DEPARTMENT OF PLANNING AND ZONING PLANNER'S REPORT

DATE: September 11, 2019
 TO: Tonya Hutson
 FROM: Michael Smith
 RE: **Design Review – 451 Walnut Street**

The City of Hapeville has received a design review application from Bernard Vigilance for a new single-family dwelling at 451 Walnut Street. The dwelling will have four finished bedrooms and three finished bathrooms, as well as two unfinished bedrooms and two potential bathrooms in the basement. The structure will be built on a hill, with a height of 1.5 stories at the front and 2.5 stories in the rear. The dwelling will have 2,337 SF of heated floor area, a 1,358 SF unheated basement, and a 484 SF two-car attached rear garage, with a total roofed area of 4,275 SF including a porch. The floor plan is mirrored by 449 Walnut Street.

FRONT ELEVATION

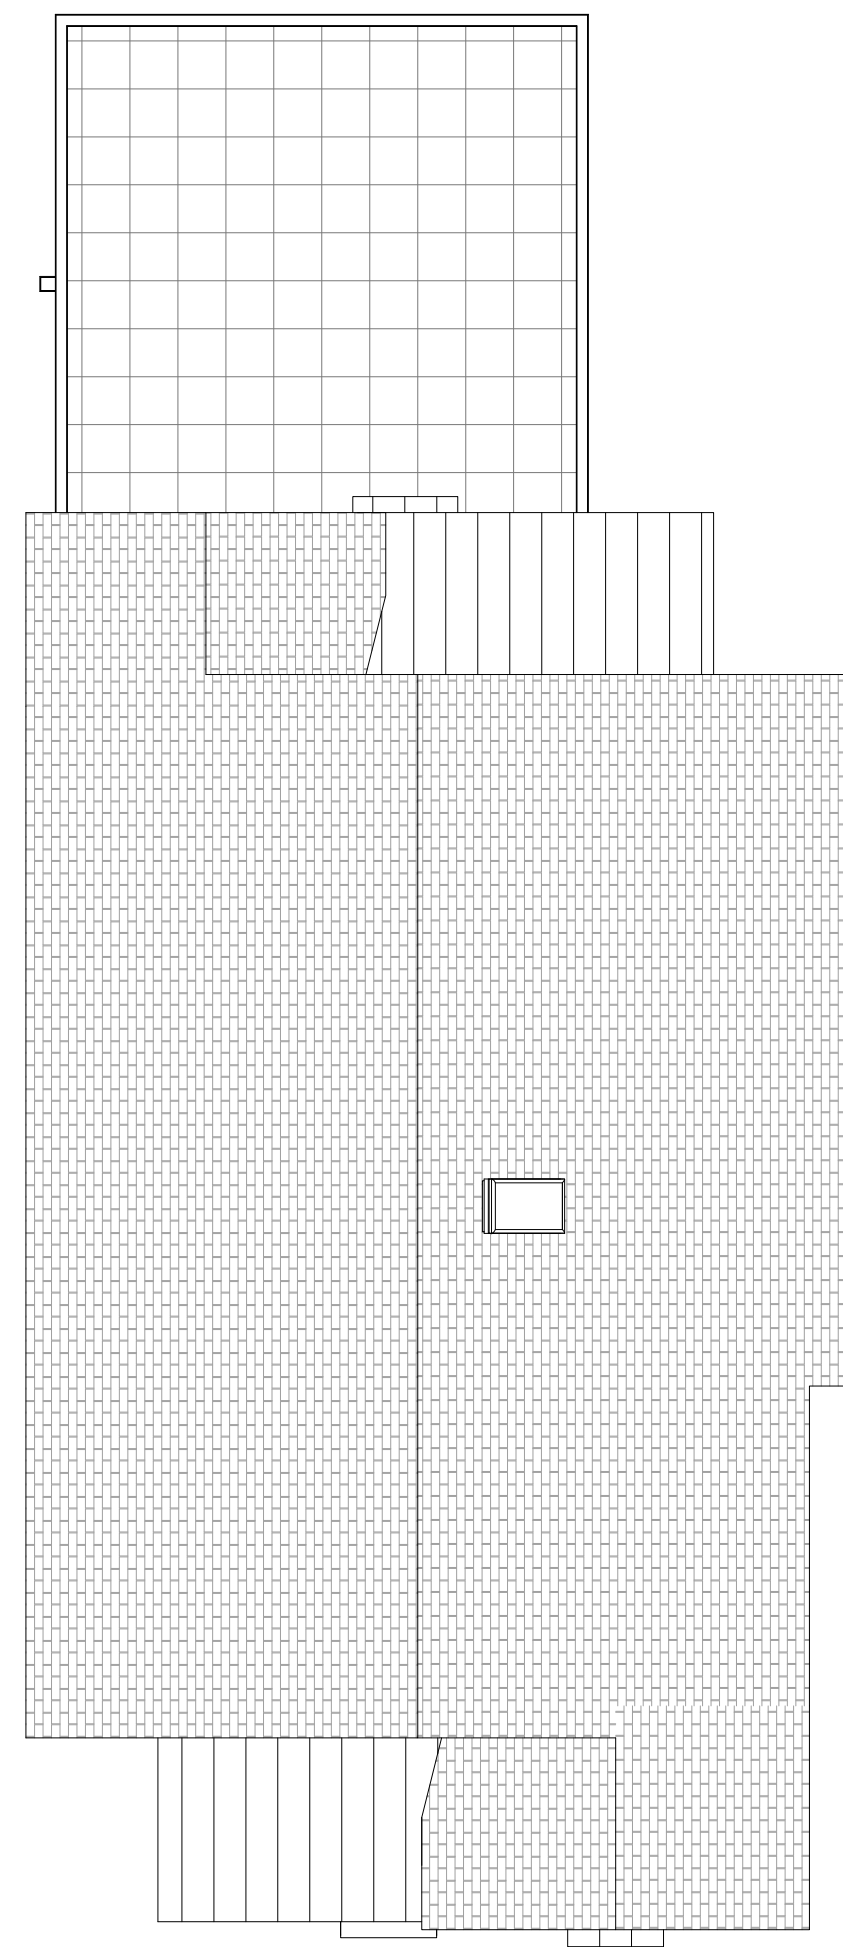
- The applicant should specify the material used for the porch and porch column.
- The porch foundation must be enclosed.
- Porches and finished first floors must be raised between 2' and 4' above grade, unless existing topography is greater. The applicant should provide the height of the porch and finished first floor from grade at the front.
- Front porch widths must be 80-100% of the adjacent façade. The proposed porch is 73% of the width of the adjacent façade/40% of the overall front façade, which is not compliant.

- The applicant should provide the height of the finished first floor above grade, ensuring it is between 2' and 4'.
- Enfronting first story windows must be between 2.5 and 3.5' above finished first floor elevation. The proposed enfronting windows are 2' above the floor, which is not compliant.
- The design does not reflect any of the principal traditional styles found in the community.

10. Front porch widths must be 80-100% of the adjacent façade. **The proposed porch is 73% of the width of the adjacent façade/40% of the overall front façade, which is not compliant.**

16. Enfronting first story windows must be between 2.5 and 3.5' above finished first floor elevation. **The proposed enfronting windows are 2' above the floor, which is not compliant.**
17. **The design does not reflect any of the principal traditional styles found in the community.**
